TBTE Ref No: 25-520

Subject: City of Ottawa File Number: D02-02-24-0029  
**Update to Environmental Site Assessment Reports**  
Concept Plan (April 2026) – 2095 Dilworth Road  
Ottawa, Ontario

TBT Engineering Limited (TBTE) was retained by Dilworth Development Inc. (Client) to update the existing Environmental Site Assessment (ESA) reports and provide responses to the City of Ottawa comments received on January 26, 2026, for the Zoning By-law Amendment application of the property located at 2095 Dilworth Road (Site) in Ottawa, Ontario.

## Attachment A – Current Potential Concept Plan

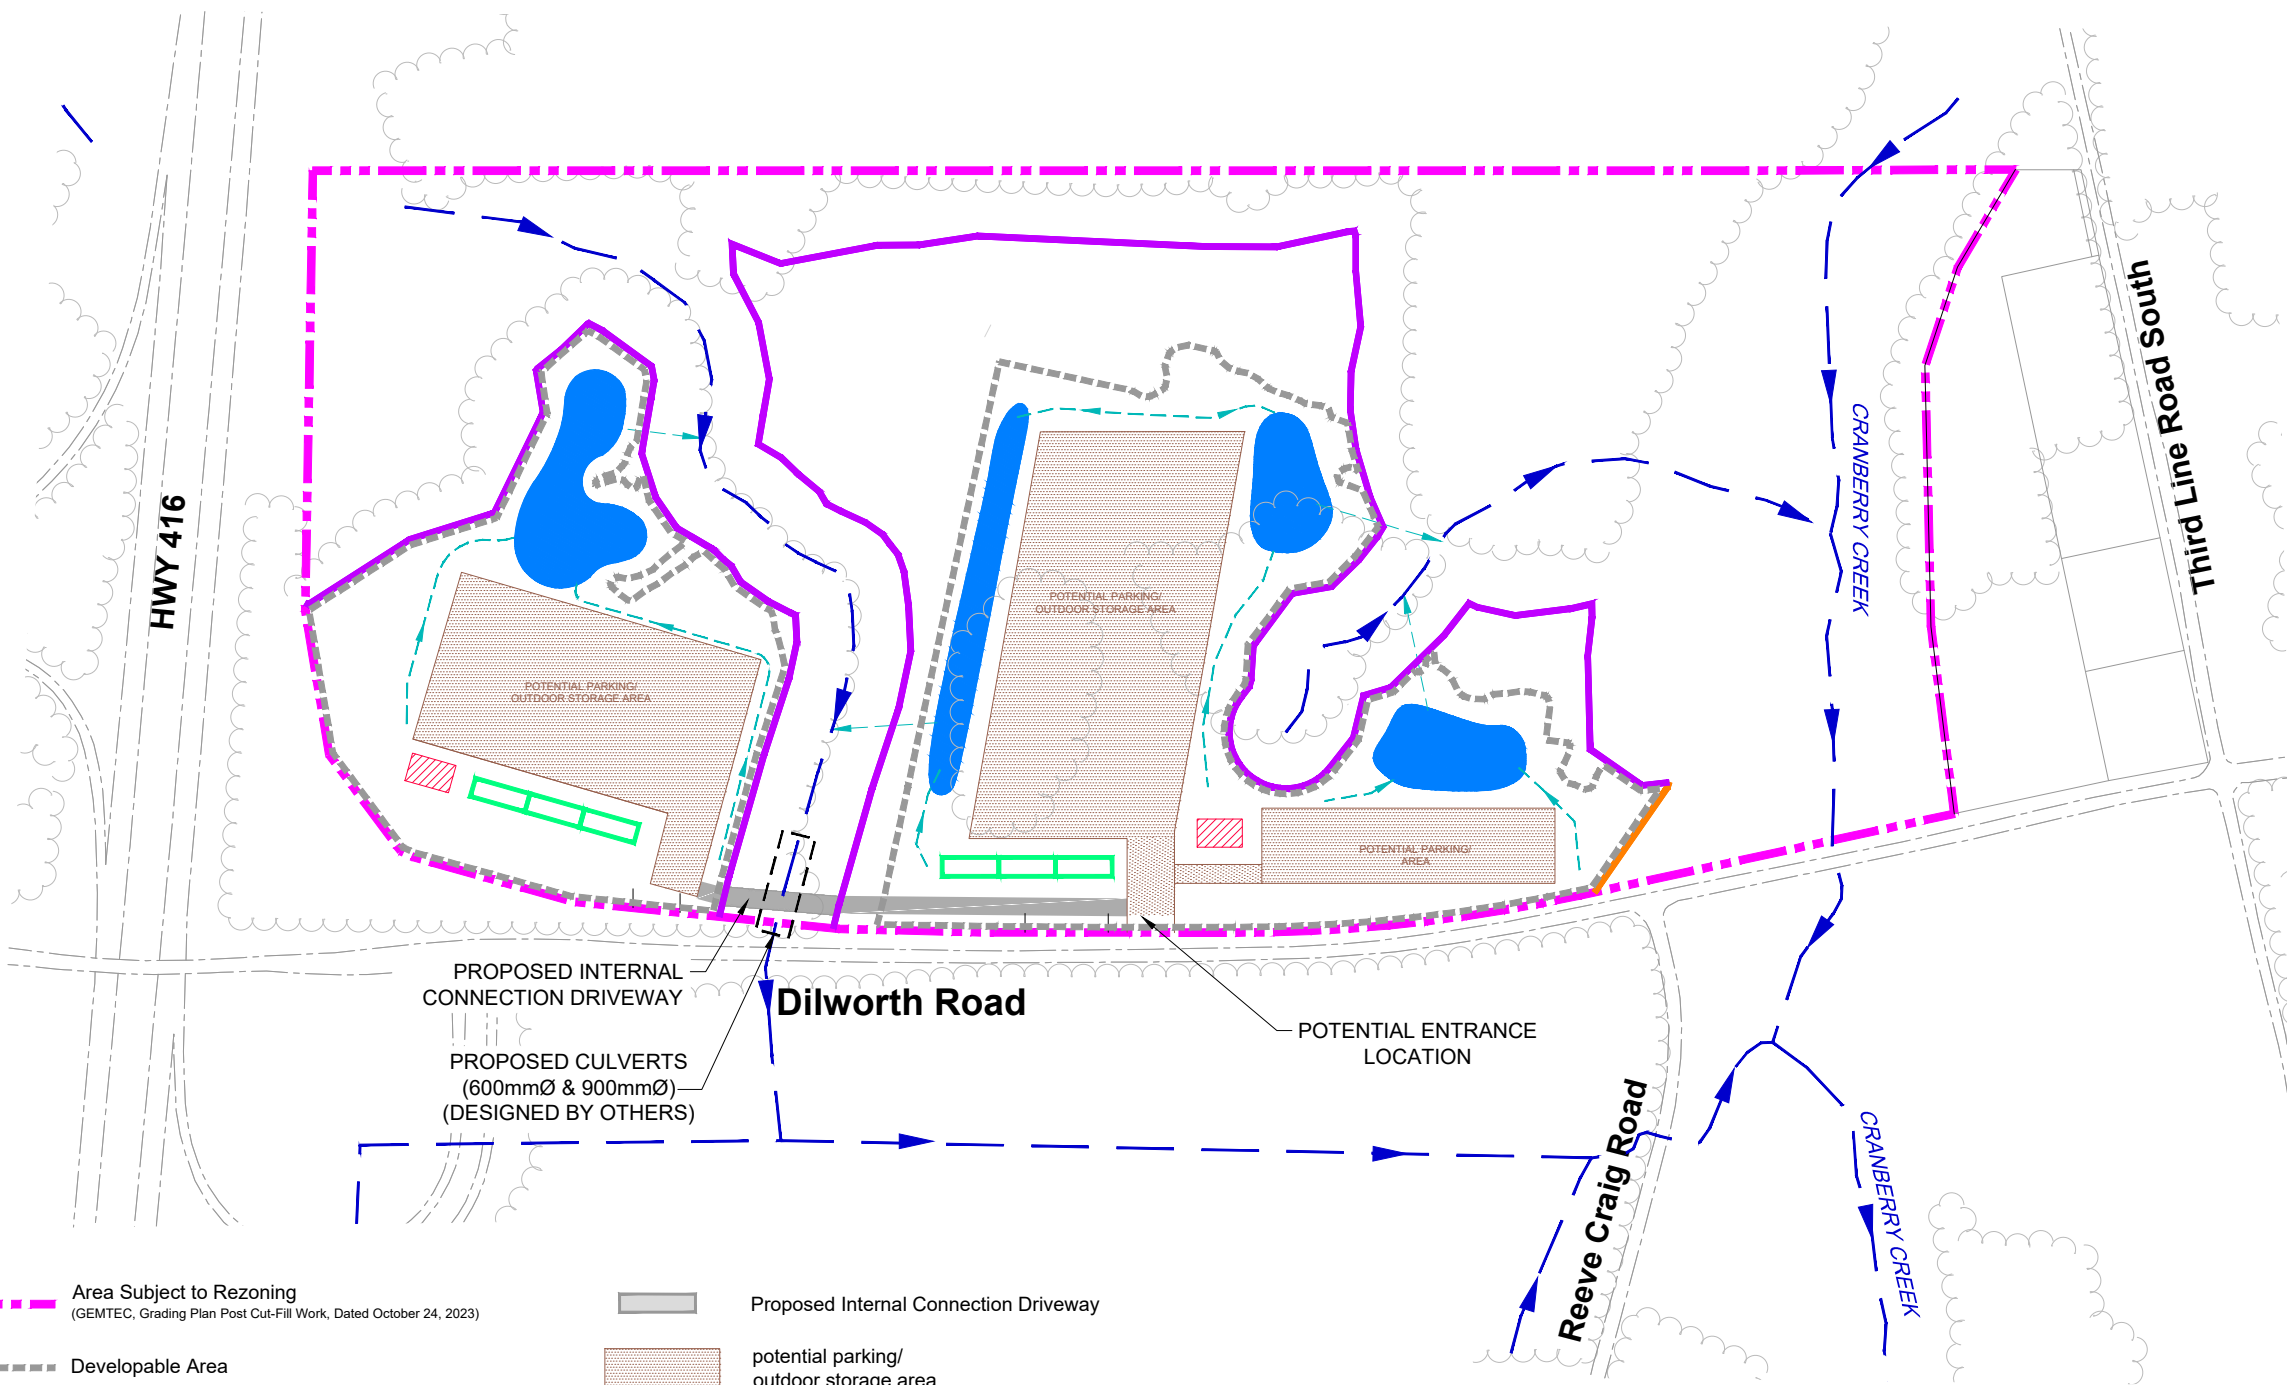
**City of Ottawa Comment 52:** *The Concept Plan indicates that the proposed zone boundaries are based on a 30m setback from non-PSWs and a 50m setback from PSWs. Revise the Plan.*

The current potential concept plan prepared by the Planner is included in Attachment A of this letter.
